**Coal Combustion Residue Impoundment  
Round 9 - Dam Assessment Report**

*Flint Creek Power Plant*

*Bottom Ash Dike*

*SWEPCO*

<p><b>Golden Associates</b> Atlanta, Georgia</p>	PROJECT No.	0539-0028-10	FILE No/CA Fig.	3-1 of 3 deficiencies	
	DESIGN	MTS	04-20-06	SCALE	1"=20'
	CHECK	AD	05-14-09	REV	0
	REVIEW	WNS	06-21-09	<b>3-1</b>

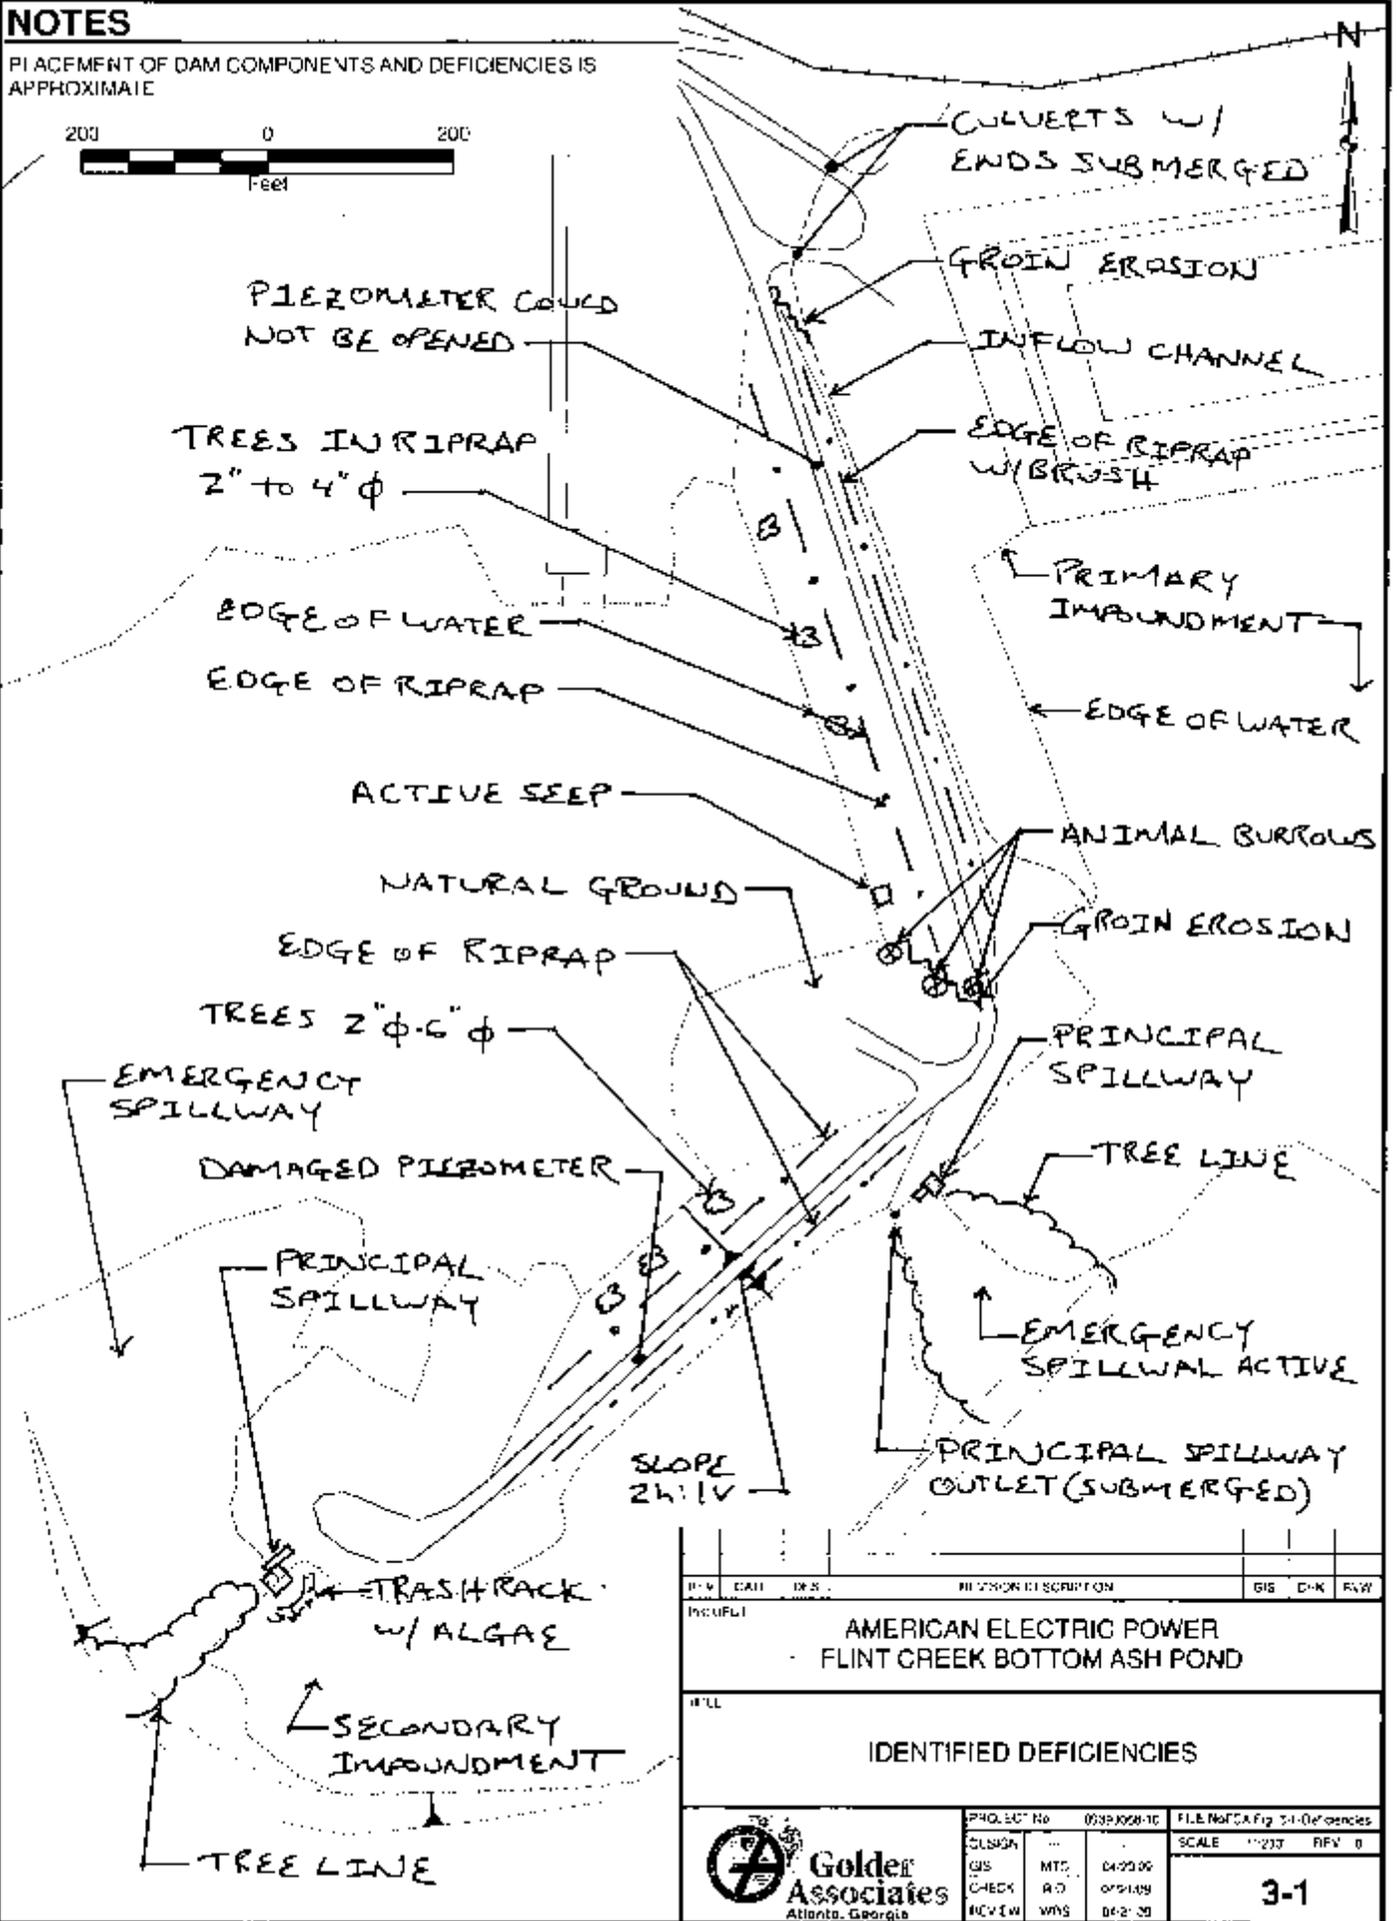
See Figure 3-1 for the location of structures and deficiencies itemized below.

18.) Piezometer  
Secondary Impoundment  
Poor condition.

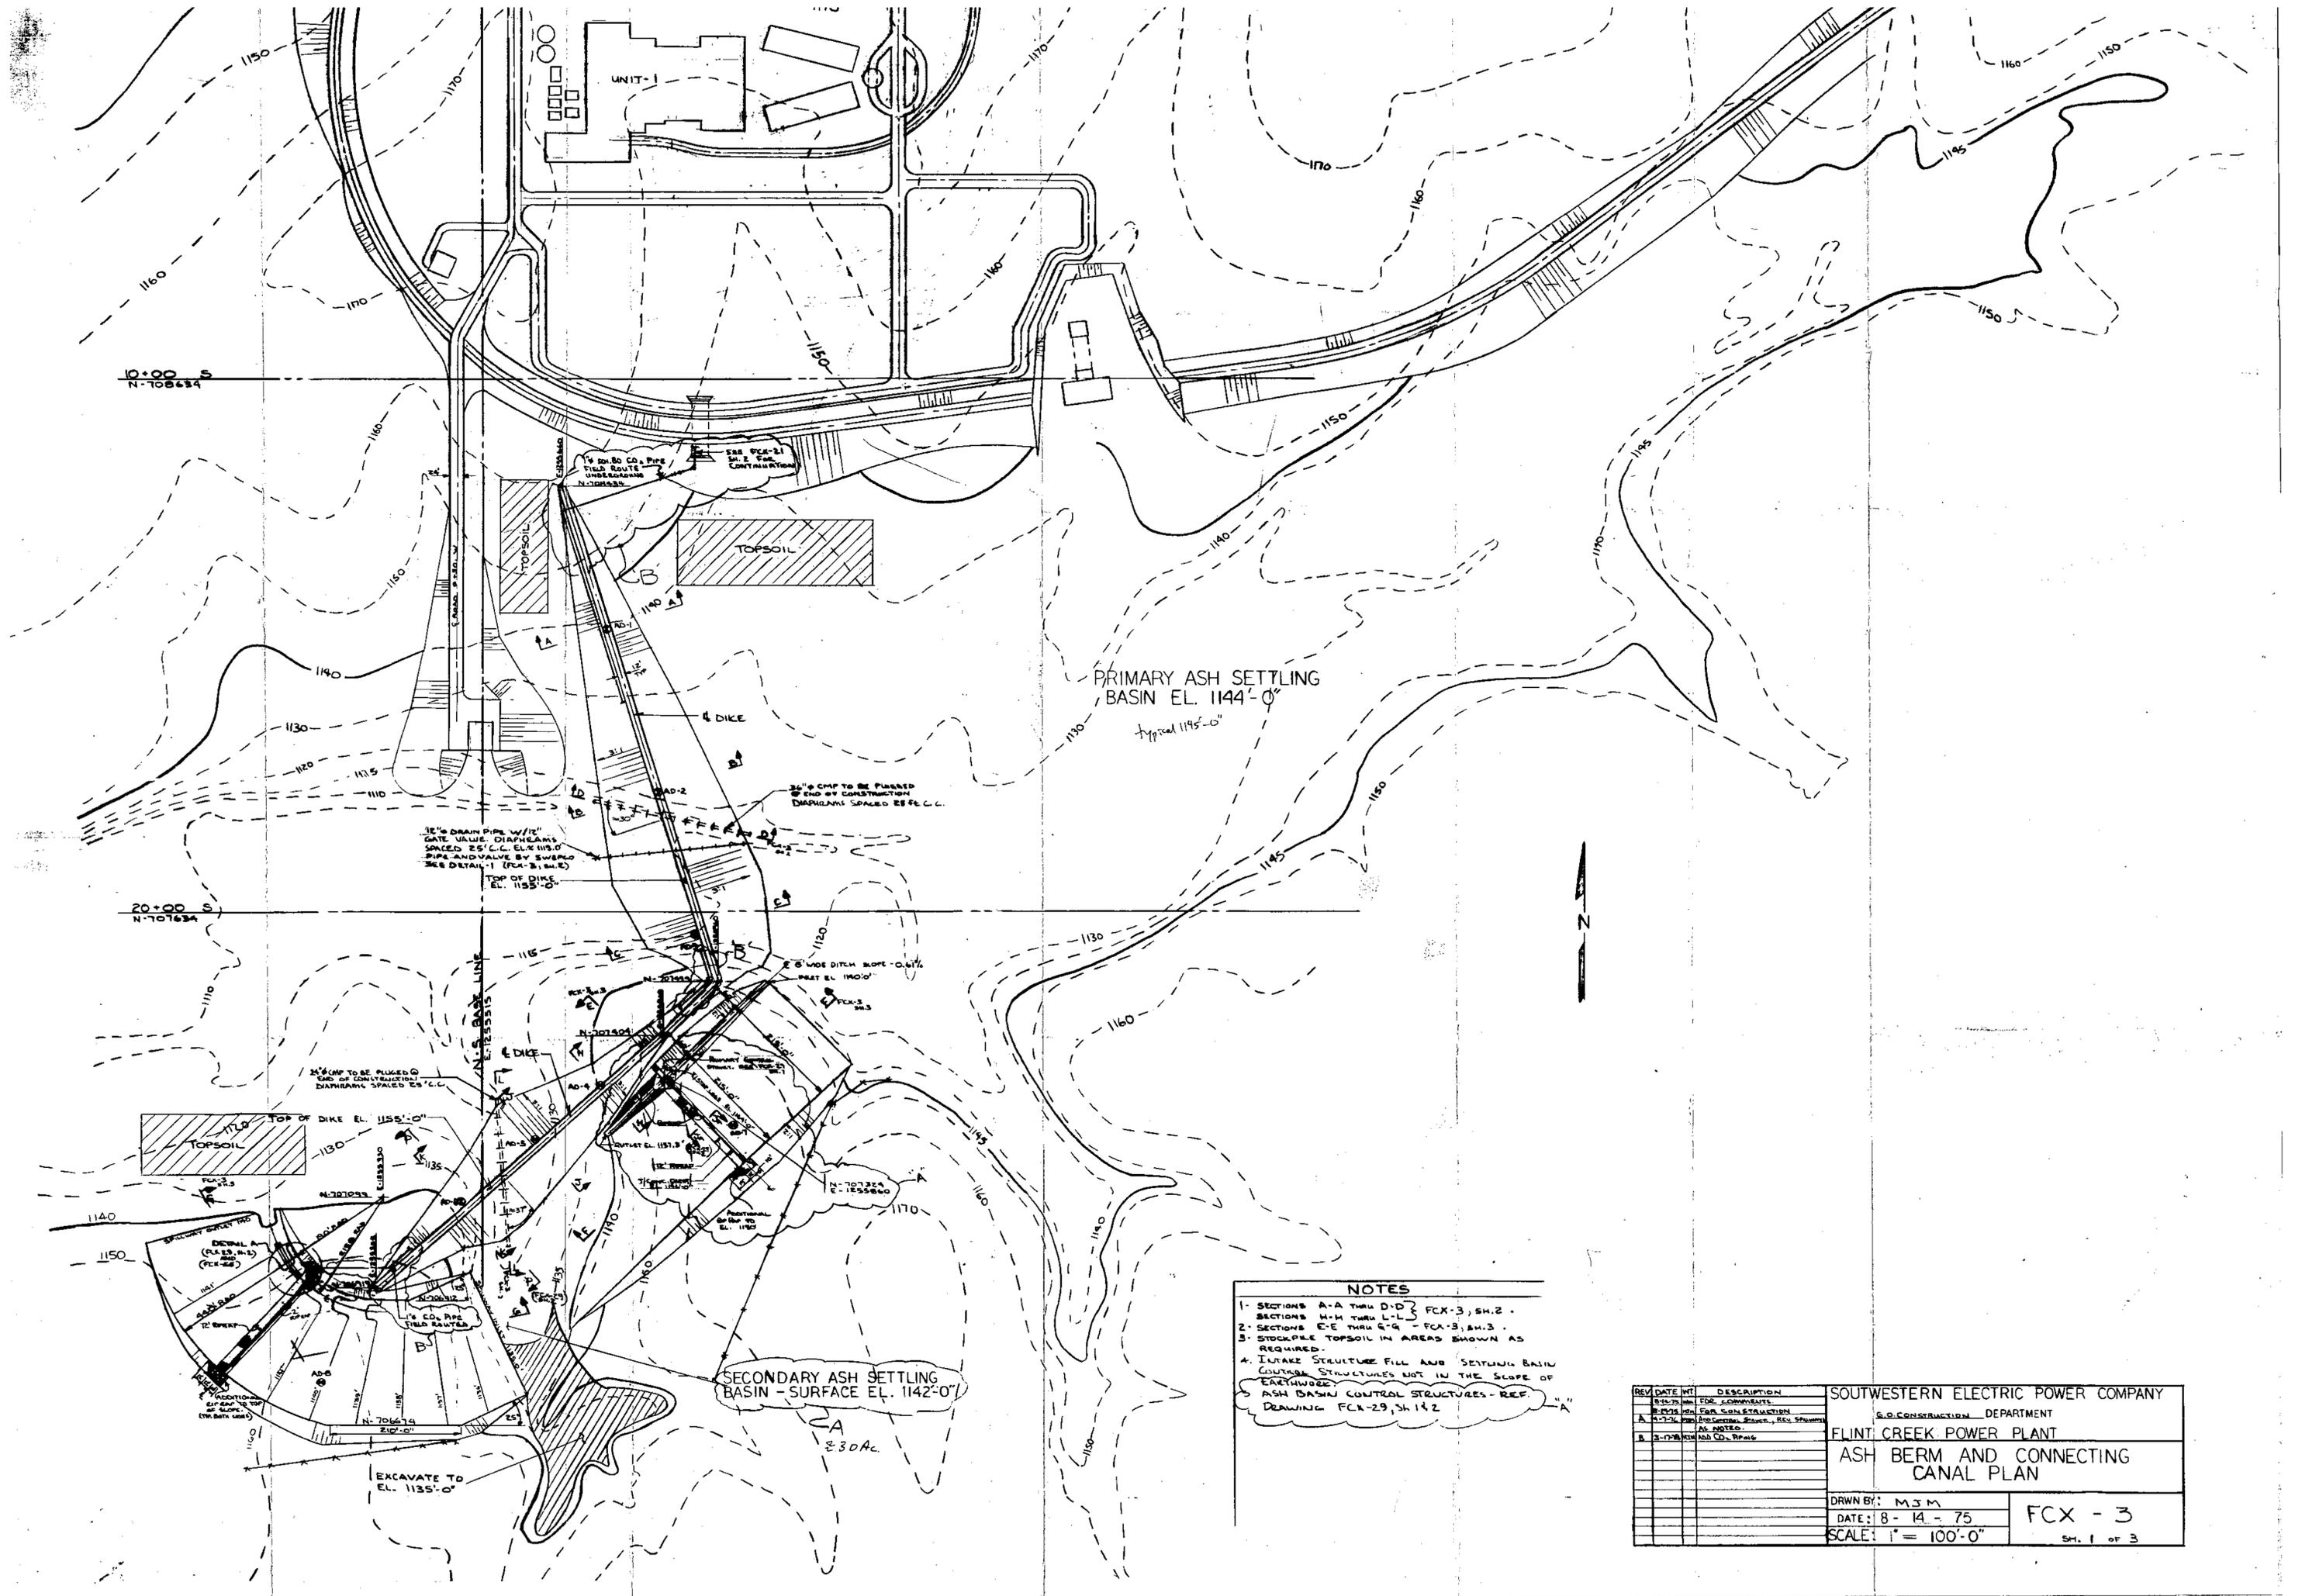
- Open, inspect and read piezometer on the primary embankment. Further excavate, and repair/replace the outer casing of the piezometer on the secondary embankment.

Photo 5. Secondary ash pond principal spillway weir with minor growth of woody vegetation and active emergency spillway prepared for reconstruction.

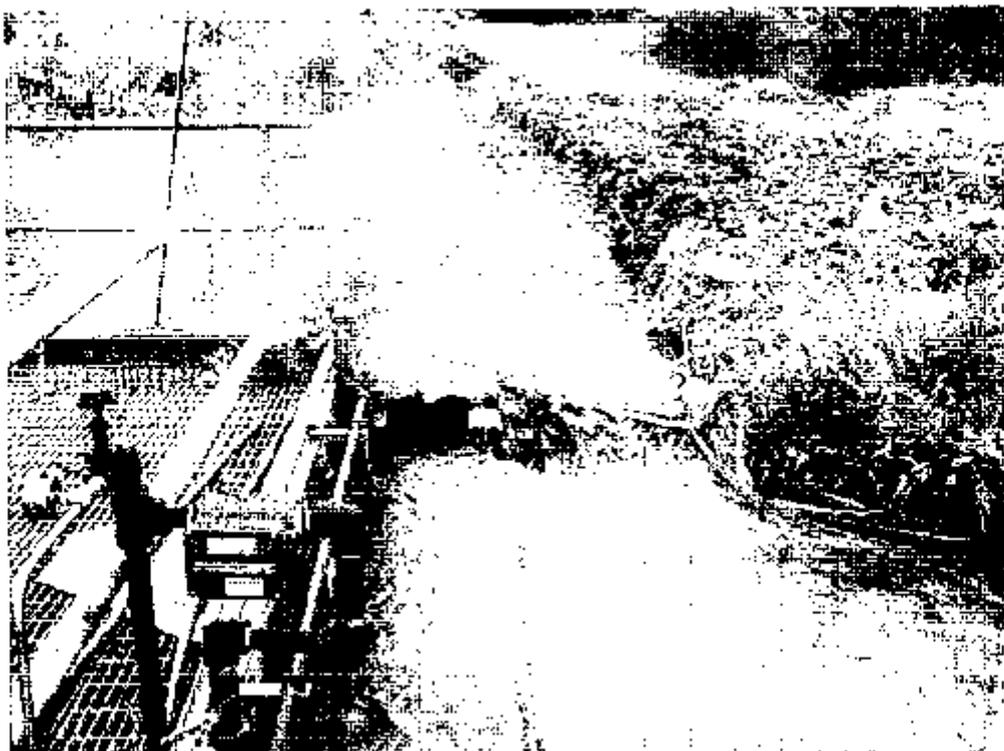
The principal spillway at the secondary impoundment, shown in Photos 4 through 6, consists of a concrete outlet structure with a series of horizontal orifices and a weir that discharges to an open cut channel. The concrete and metal components of the outlet structure were observed and noted in fair condition. Significant growth of woody vegetation, including one tree over 15 feet in height was observed adjacent to the outlet structure. Minor growth of woody vegetation was observed growing just upstream of the weir. The discharge channel was in fair and stable condition. The plant has reportedly cleared the vegetation from the spillway and controlled further growth since the time of inspection.
